**FACSIMILE MEMORANDUM SHEET**

Subject: Kawahara Nursery, San Lorenzo

**Subject: Proposed Soil Bore Locations  
Kawahara Nursery  
16550 Ashland Avenue, San Lorenzo, CA**

FIGURE  
**1**

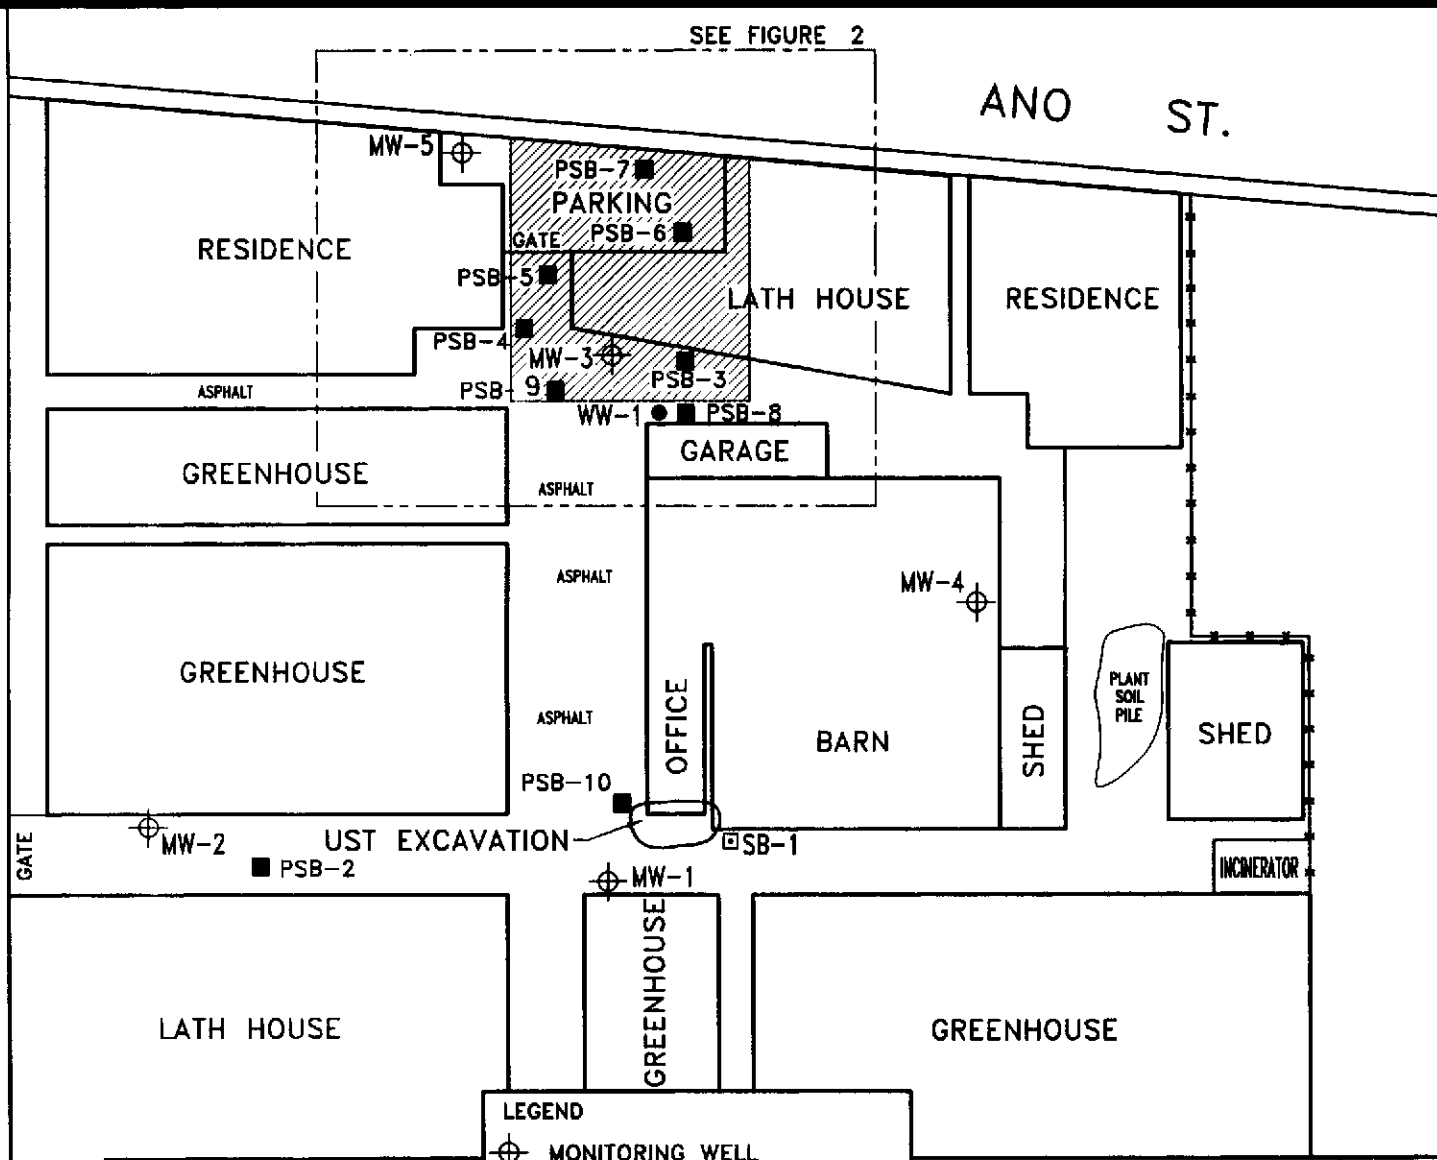
The attached site plans (Figures 1 and 2) indicate the locations of three soil bores (PSB-8, PSB-9, and PSB-10), in addition to the six soil bores already proposed (PSB-2 through PSB-7). PSB-8 and PSB-9 are located east and west of MW-3, respectively. Soil bore PSB-10 will be drilled north of MW-1 and immediately downgradient of the former diesel UST location, as requested.

FIGURE  
**2**

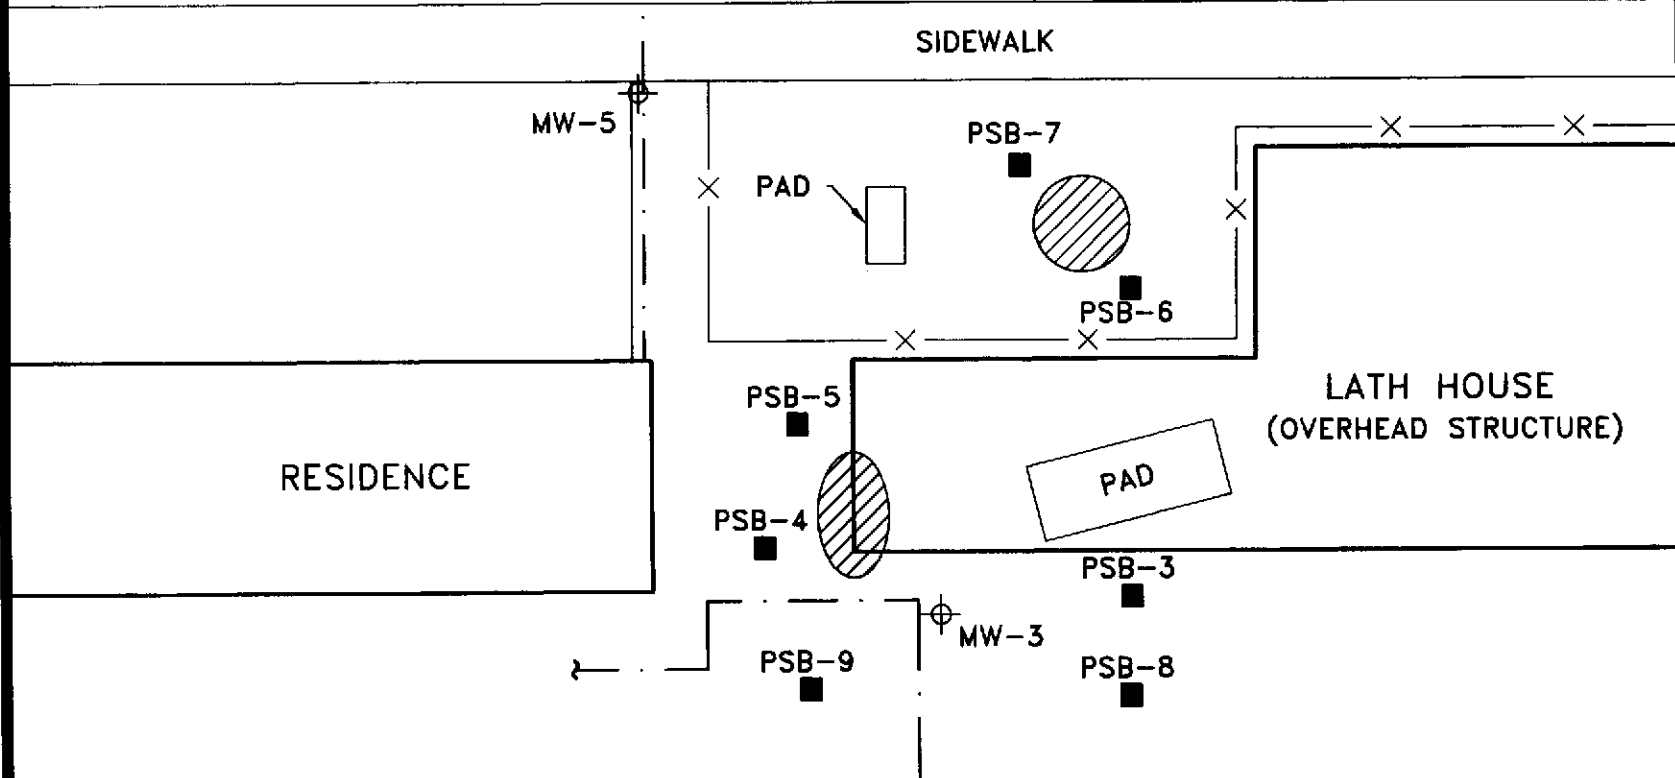
The magnetic anomalies represent suspected UST locations (west and north of the lath house). Soil bores PSB-4 and PSB-5 are on the downgradient perimeter of one anomaly, approximately 5 feet from it (Figure 2). Upgradient locations were not proposed because of underground utilities and the presence of the lath house. We believe that the downgradient perimeter locations proposed should be adequate to assess any soil or groundwater contamination that may have resulted from a leaking UST at the location of the anomaly. The proposed locations of PSB-6 and PSB-7 are approximately

3 or 4 feet from the magnetic anomaly north of the lath house (in upgradient and downgradient locations, respectively). No additional soil bore locations are proposed there.

FIGURE  
1

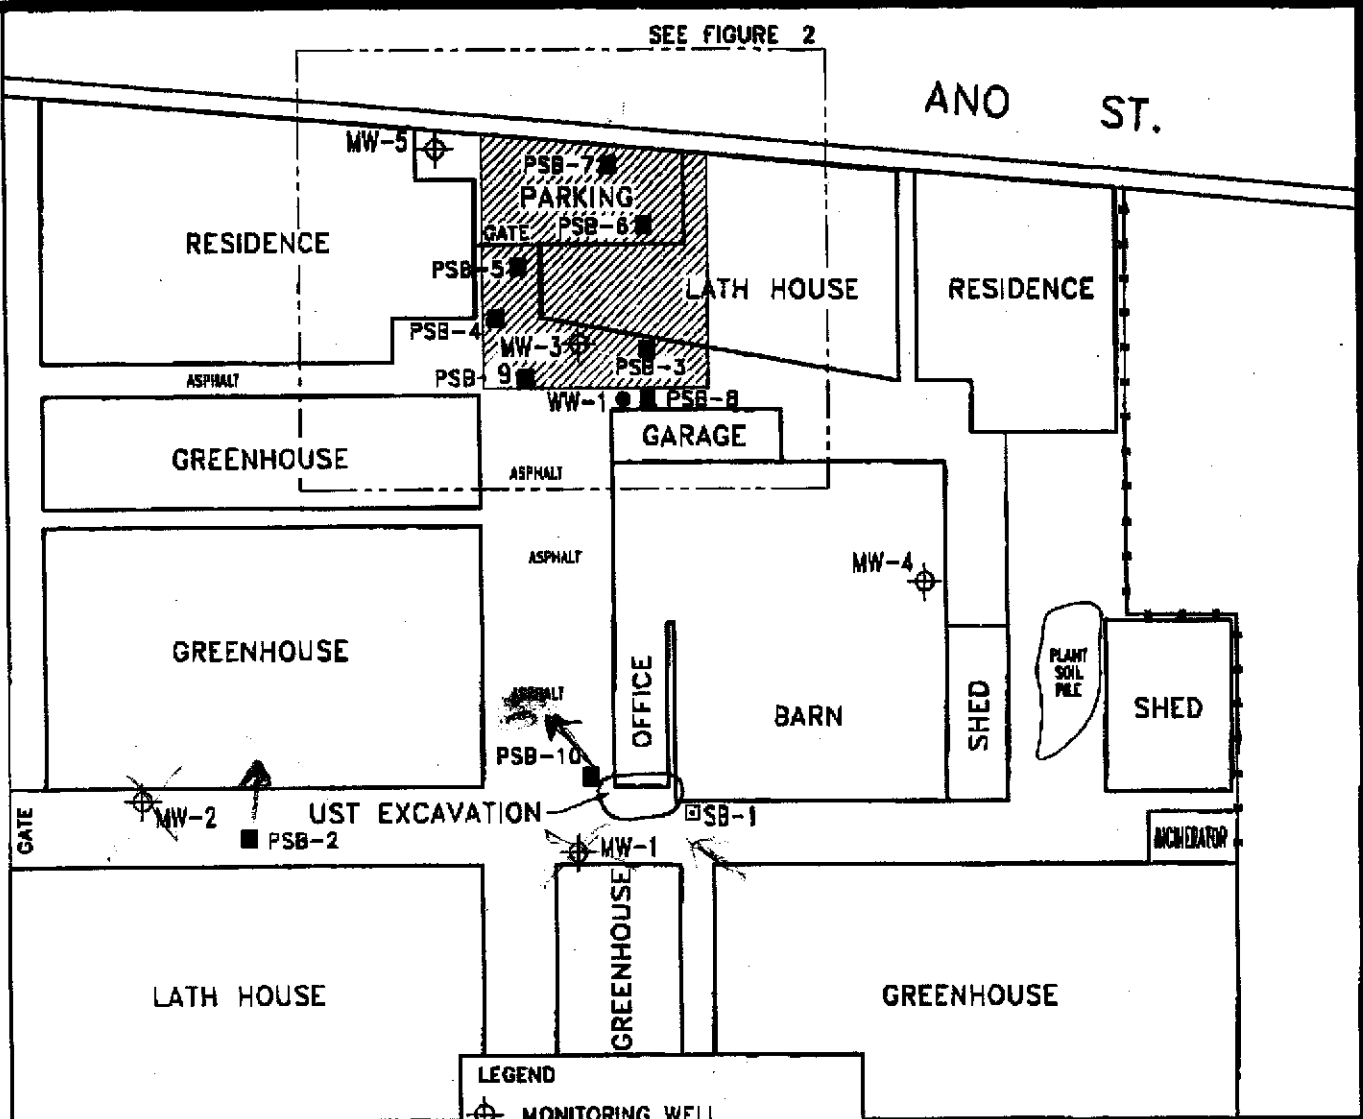
The attached site plans (Figures 1 and 2) [REDACTED] PSB-8 and PSB-9 are located east and west of MW-3, respectively. Soil bore PSB-10 will be drilled north of MW-1 and immediately downgradient of the former diesel UST location, as requested.
